FACILITY COMPLIANCE AUDIT REPORT
Division of Waste Management
Solid Waste Section

Dates of Audit: 06/11/10

Haywood County Municipal Solid Waste Landfill
 State Road 1338, White Oak Community
 Waynesville, N. C. 28786

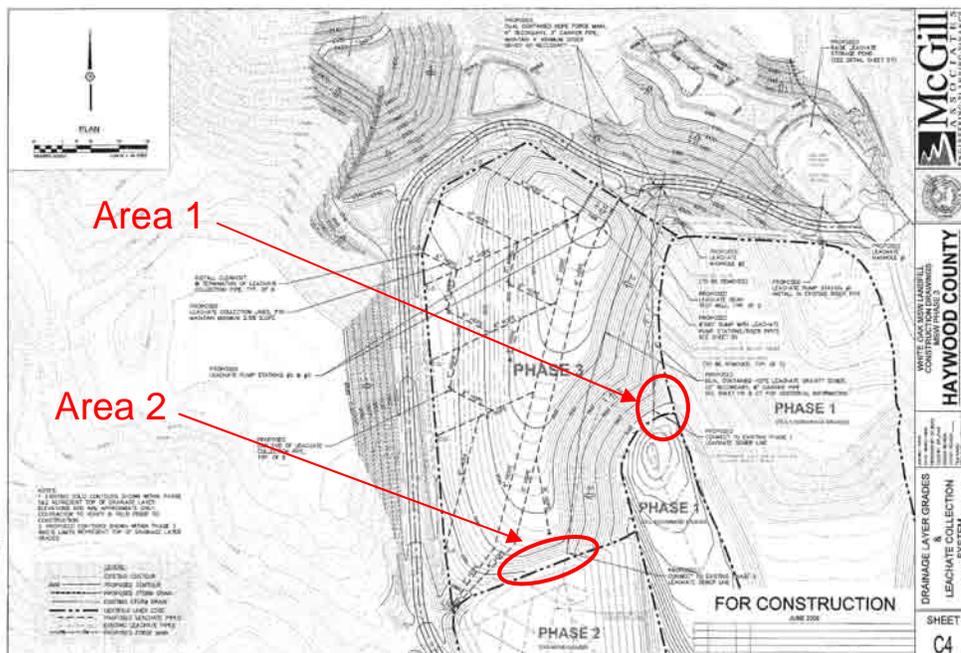
As the current explosive gas monitoring language and associated site maps found in the Permit to Construct do not reflect current site conditions, a stand-alone Landfill Gas Monitoring Plan is required. This Landfill Gas Monitoring Plan must be submitted to the Section for review, by July 12, 2010, in accordance with 15A NCAC 13B .1626 (4) and shall include, at a minimum, landfill gas well construction diagrams, a site map indicating existing and proposed landfill gas wells, a schedule for installation for all proposed well locations, and a monitoring data collection sheet indicating all site wells and reporting standards.

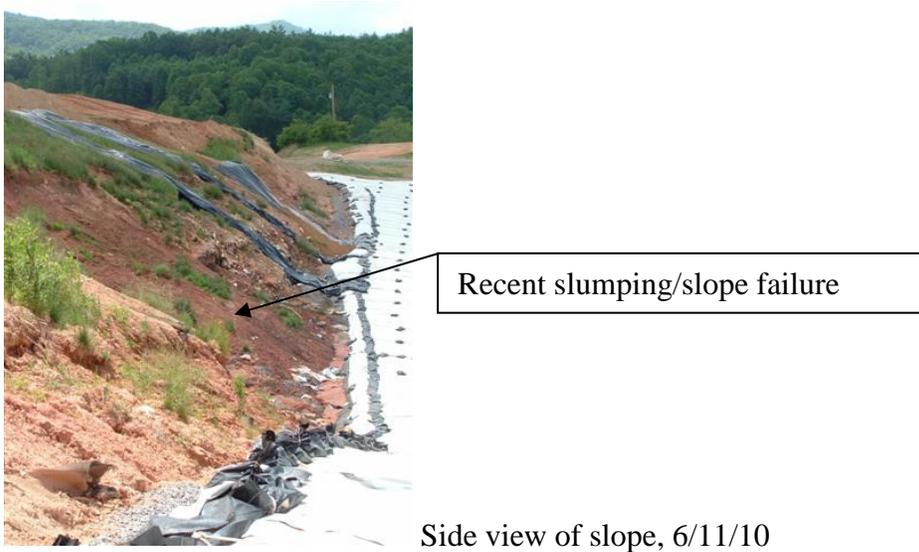
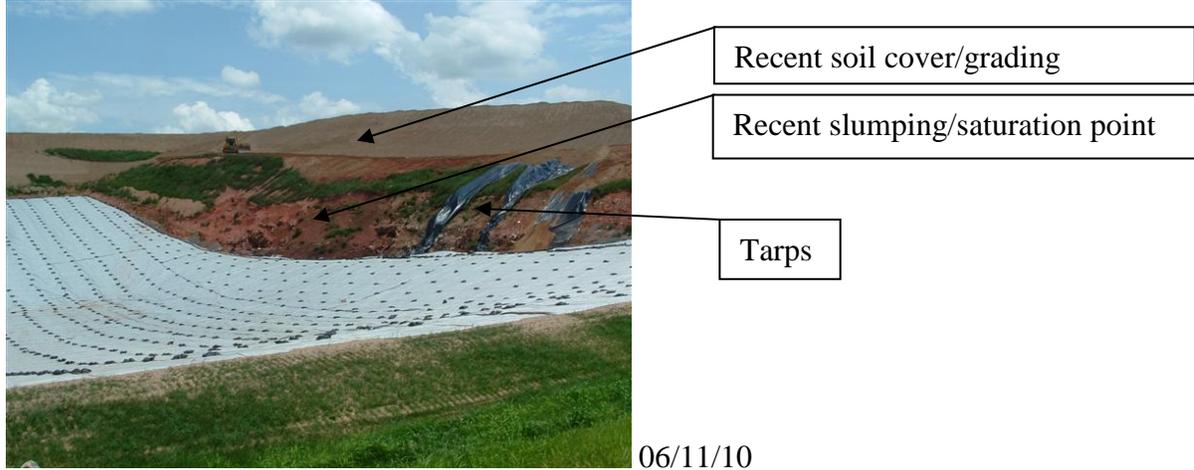
3. Substantial work had been conducted in Area 1 since the previous inspection. Excavation, soil cover, and grading had been conducted in order to cover all exposed wastes.
